RS-18-005

Clinton Power Station, Unit 1
Facility Operating License No. NPF-62
NRC Docket No. 50-461

Subject: License Amendment Request to Incorporate Revised Alternative Source Term Dose Calculation

CLINTON POWER STATION UPDATED SAFETY ANALYSIS REPORT
FIGURE 15.6.5-1 Page 1 of 2 Schematic of LOCA Transport Pathways

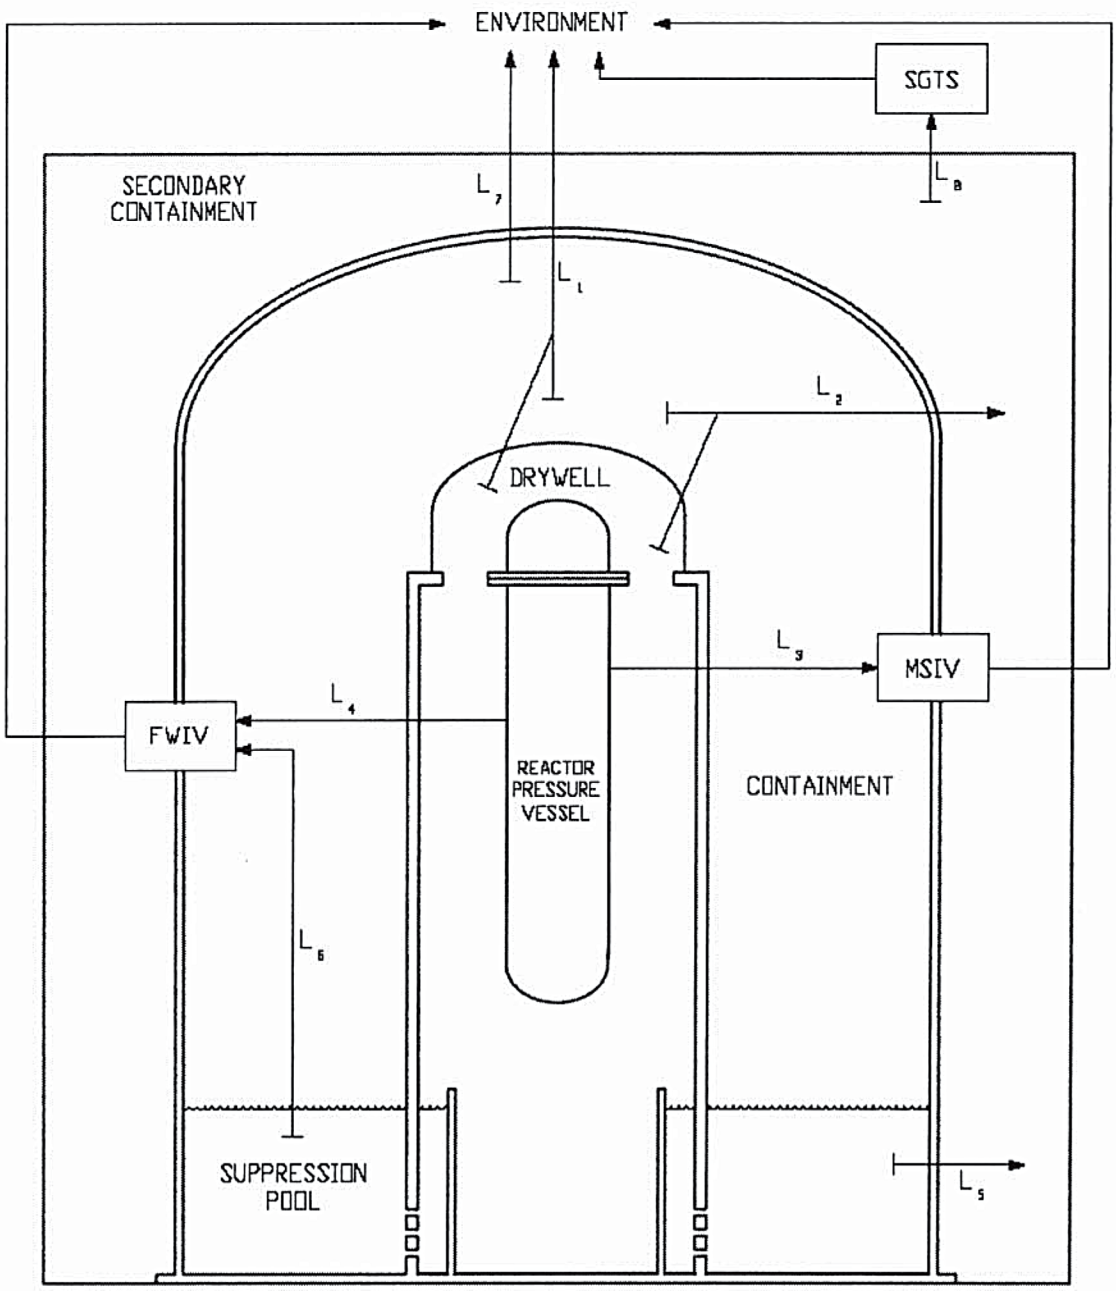
Figure 15.6.5-1 provides schematic of LOCA transport pathways.

Leakage Rates and Secondary Containment Mixing Parameters		
Path	**Description**	**Parameters & Values**
L_1	Primary Containment Leakage Bypassing Secondary Containment to the Environment	Leak Rate: $0.08*L_a$ = 0.052%/day from 0 to 24 hours = 0.033%/day from 1 to 30 days
L_2	Primary Containment Leakage to Secondary Containment	Leak Rate: $0.92*L_a$ = 0.598%/day from 0 to 19 min Unfiltered during drawdown period and includes the two minute gap release time. $0.92*L_a$ = 0.598%/day from 19 min to 24 hrs SGTS filtered = 0.380%/day from 1 to 30 days SGTS filtered
L_3	MSIV Leakage to Environment	Leak Rate: 200 scfh for all main steam lines, 100 scfh for maximum for any one MS line; reduced to ~~63.6~~62.0% of these rates after 1 day
L_4	FWIV Containment Air Leakage to Environment	Leak Rate: ~~10.98~~ 8.64 cfm total, for the one hour before FWIV LCS fills the lines
L_5	ECCS Leakage to Secondary Containment	Leak Rate: 5 gpm from 0 to 30 days
